Warragamba Dam Raising Project SSI-8441

Submission by Ted Woodley¹

11 December 2022

Figure 1 – Relative contribution of river catchments in the Valley (Figure 2 in EIS)

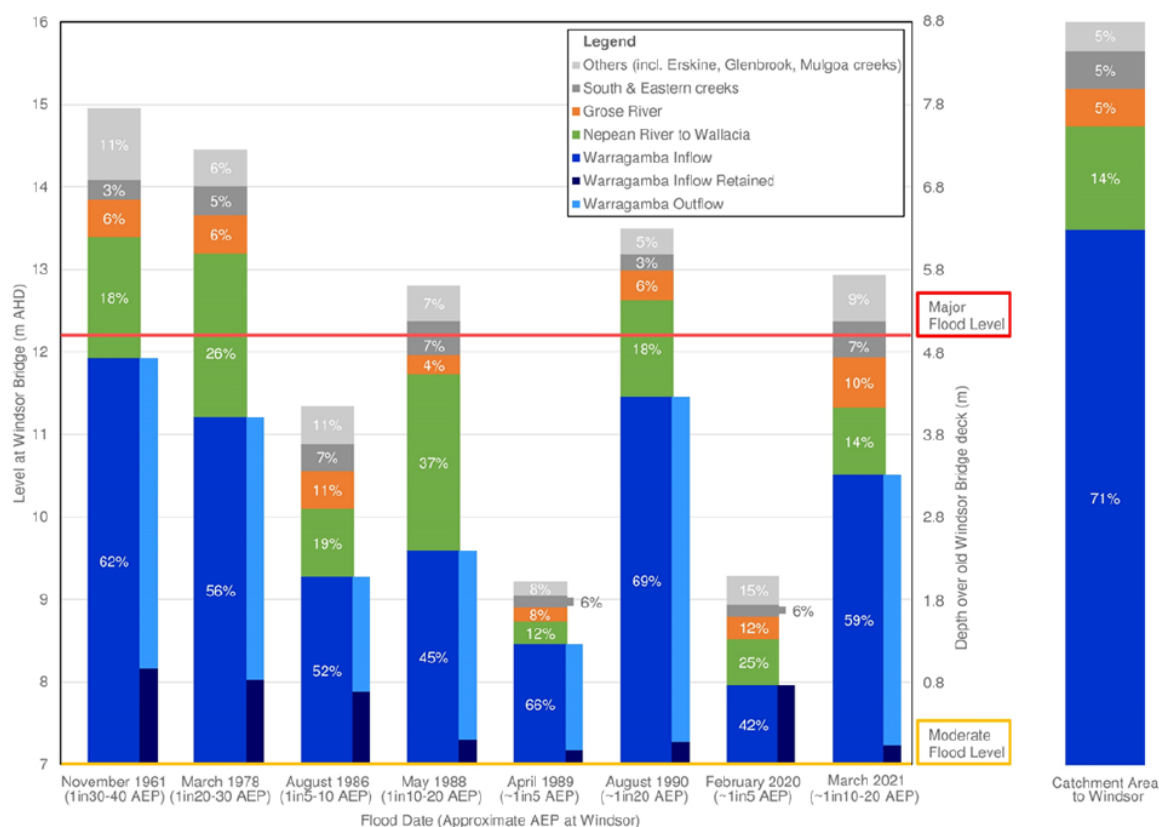
This statement is repeated throughout the EIS, but it is highly misleading and beside the point.

Figure 2 shows relative contributions from the Warragamba catchment for the eight largest floods in the sixty years since the Dam was commissioned. The Figure focuses on Warragamba inflows from its catchment (dark blue bars).

But inflows are irrelevant as far as downstream flooding is concerned, as is the ‘up to 70%’ contribution quote.

The only relevant contribution to flooding is the outflow from the Dam to the Valley (light blue bars), which is obviously less than the inflow by the amount retained in the Dam (black bars) – i.e. the spare capacity in the Dam at the time.

Figure 2 indicates that outflows from Warragamba Dam during the eight floods contributed 0% to

65% to downstream flooding, averaging slightly less than half:

- Warragamba Dam did not contribute at all to the February 2020 flood, as the Dam did not spill – it was at less than 50% capacity at the time.
- The maximum contribution to flooding from Warragamba Dam occurred in the August 1990 flood, at around 65%.

Figure 2 – Discharge Hydrograph for 1 in 100 Year Flood (Figure 15-36 in EIS)

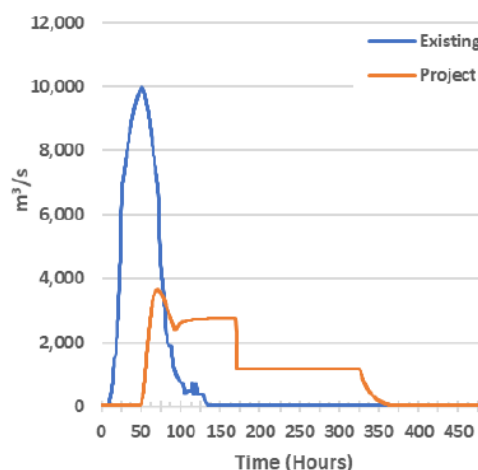
The graph indicates that all inflows up to that time, when the flood peaks, are contained in the FMZ, and that the subsequent releases are controlled according to the proposed drawdown procedure outlined in Section 2.3.

However, Figure 5 indicates that a 1 in 100-year flood would reach 15.3 metres above FSL, 3.3 metres over the crest of the central spillway and 1.3 metres over the auxiliary spillway, resulting in uncontrolled spilling from both spillways. This uncontrolled discharge is not evident in Figure 2. Can this apparent anomaly be explained?

If Figure 2 is in error, the downstream flows from Warragamba will be much higher and possibly start earlier than indicated. If so, the flood mitigation benefits of the dam raising will have been overestimated. The impact of this misrepresentation would be even more acute for a flood of greater than 1 in 100-years.

- vii) Are the discharge hydrographs (e.g. Figure 2) correct, and take into consideration uncontrolled discharges above the two spillways?
- viii) Doesn't using a 20-year period tend to understate the average inundation depth?

Figure 4 – Dam wall: Depth-duration curves (Figure 15-30 in EIS)

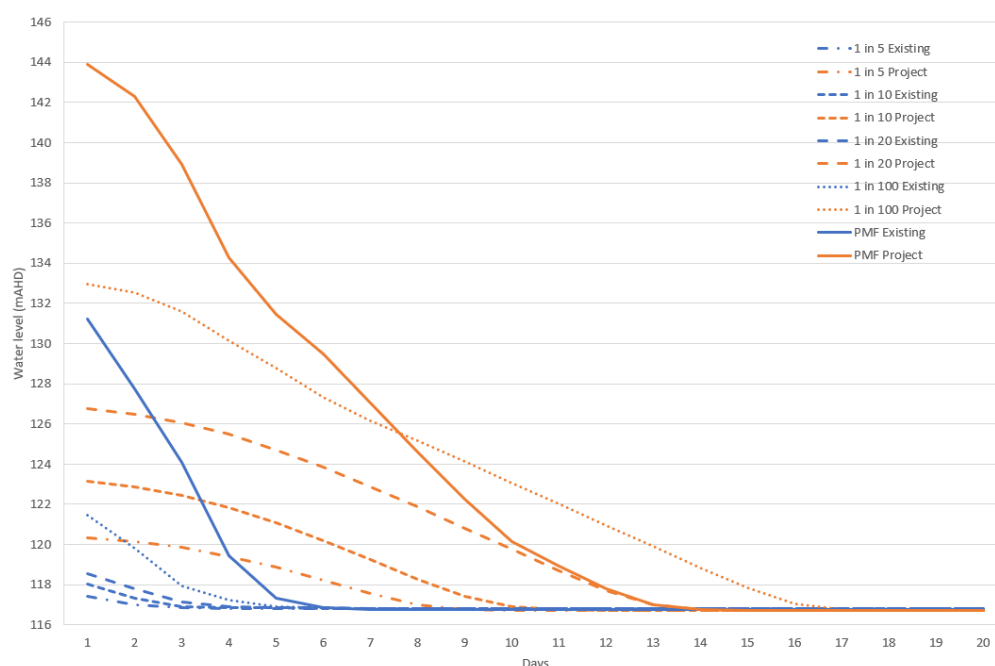
The information provided in these figures is incorrect and inconsistent. The title in Figure 3 under Project should be 'Increase in Depth (m)', not 'Depth (m)', while the time for emptying the FMZ after a 1 in 100-year flood is shown as 4.0 days (existing) and 14.8 days (Project) in Figure 3 but 5.5 days and 16.5 days in Figure 4.

A minor point noted earlier is the slightly longer durations for a 1 in 100-year flood of 14.8 days (Figure 3) and 16.5 days (Figure 4).

Figure 7 – Historic Dam levels (Figure 15-8 in EIS)

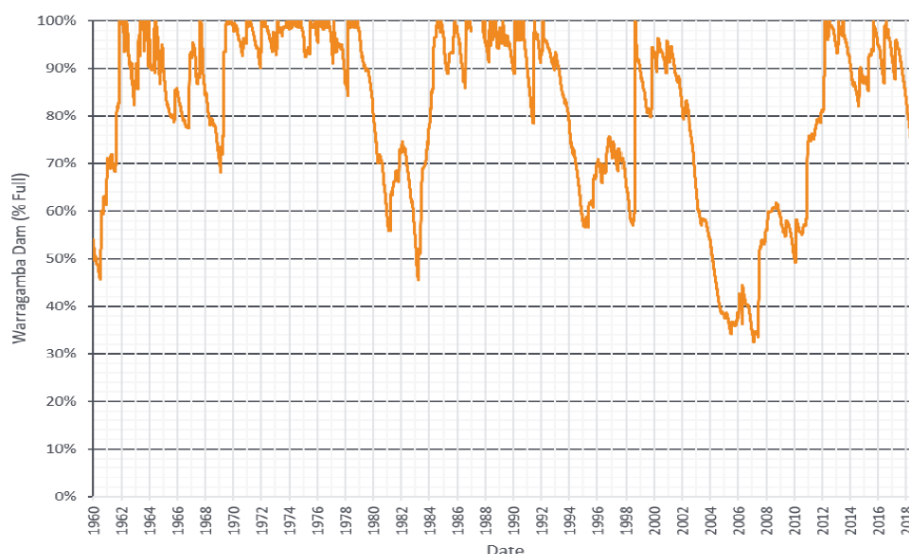
It is comforting to note that the historic levels of Warragamba have been relatively high (see Figure 7), never dropping below 30%. Had a regime been in place to lower the FSL to 82% when a flood was looming, the only time this may have triggered the need for alternate water supplies would have been once in the past sixty years (2004 – 2008).
